STAFF REPORT

To: Design Review Board
Date: October 8, 2020
Case: Architectural Design Review (Major) Case No: AR-20-19 Kiddie Academy
Prepared By: Patrick Reidy, Senior Planner

Requested Action: Review and approval of the Architectural Design Review (Major) application for Kiddie Academy

4 SOUTHEAST ELEVATION - GATEWAY COMMONS ENTRANCE
 SCALE: 3/32"=1'-0"

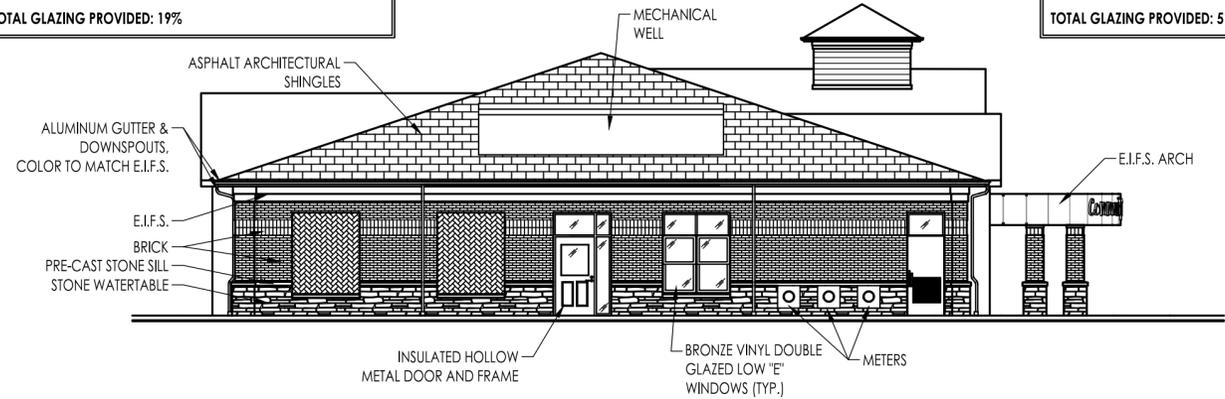
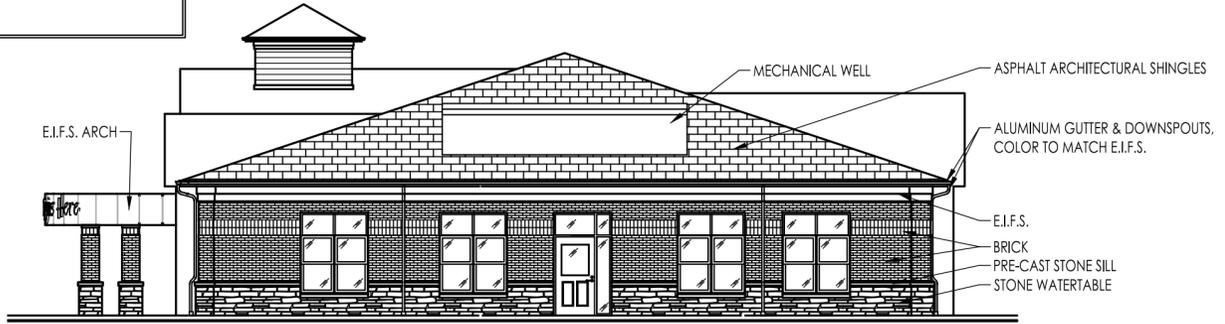
All the proposed side building facades meet the 40% minimum requirement. The exterior façade facing the Gateway Commons Entrance provides 51% transparency.

2 NORTHEAST - JONES DAIRY ROAD
 SCALE: 3/32"=1'-0"

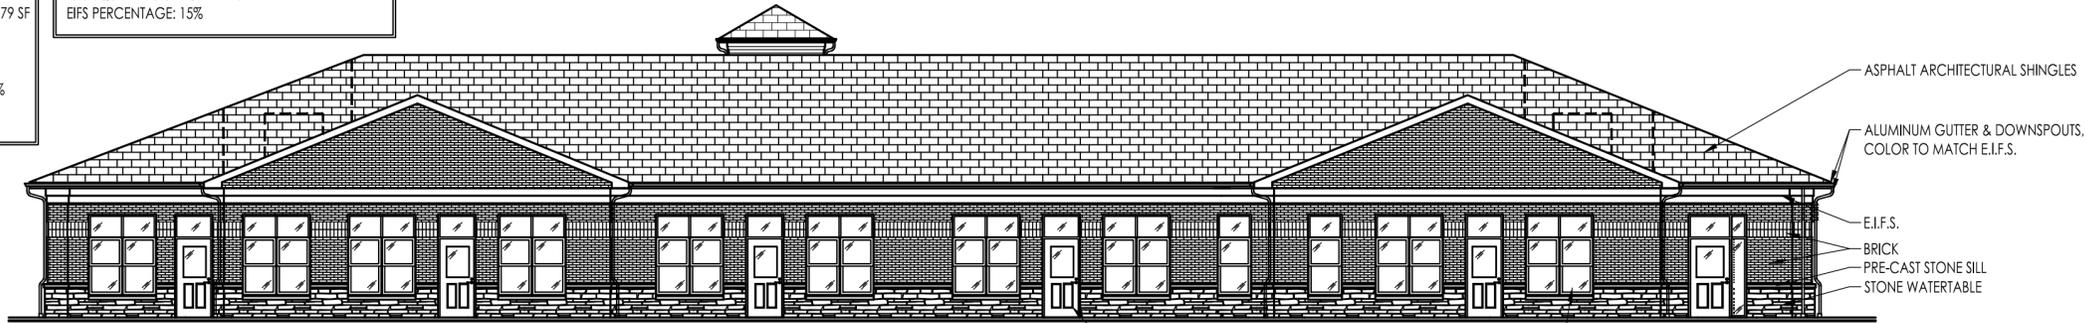
Staff Analysis: All the proposed building facades that face a street lot line meet the 50% minimum requirement. The front façade facing Gateway Commons Circle provides 59% transparency. The façade facing Jones Dairy Road provides 60% transparency.

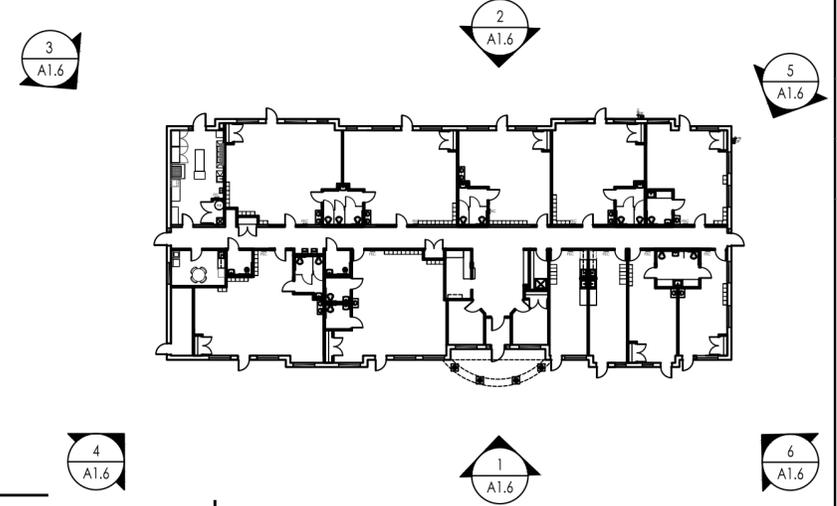
Staff Analysis: The utilities will be placed on the roof using mechanical wells to be screened from view UDO. Roof lines are shown in relation to the rooftop equipment. The Design Review Board will need to determine if the rooftop equipment requirement is being met.

NOTES:
ROOFTOP EQUIPMENT TO BE PAINTED TO MATCH ROOFING MATERIAL.
